AUTO RADIO SERVICE BULLETIN.**SUBJECT - ELIMINATION OF EXCESS CRACKLE WITH ENGINE RUNNING.**

This complaint may be noticed in Model 6395 numbering up to 36,300 and Model 12395 numbering up to 44,011.

FIG. 1.

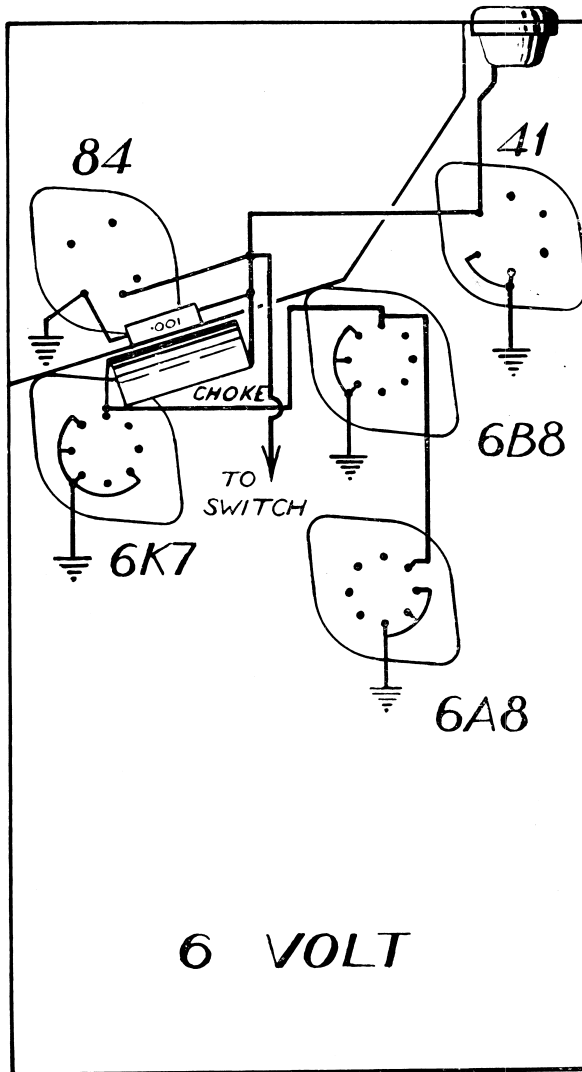
1. Fit a small hash choke (PT137) in Model 6395 filament circuit to isolate the first three tubes (6A8, 6K7 and 6B8) from the rest of the filament and field circuits, and a .001mfd. mica condenser from the "A" side of the choke to chassis as shown in Fig. 1. In Model 12395, the hash choke will isolate only the 6A8 and 6K7 filaments as shown in Fig. 2.

FIG. 3

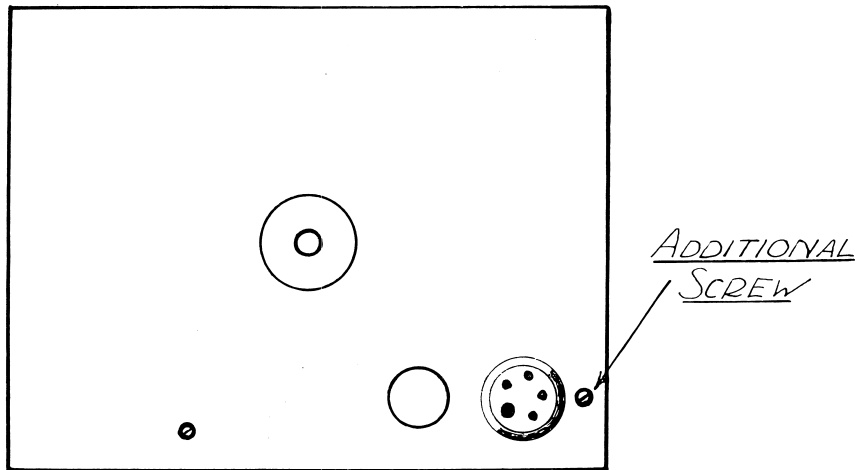
4. An additional Parker Kalon drive screw is necessary. This will be fitted in the back of the can between the speaker socket and the side of the can as shown in Fig. 3.
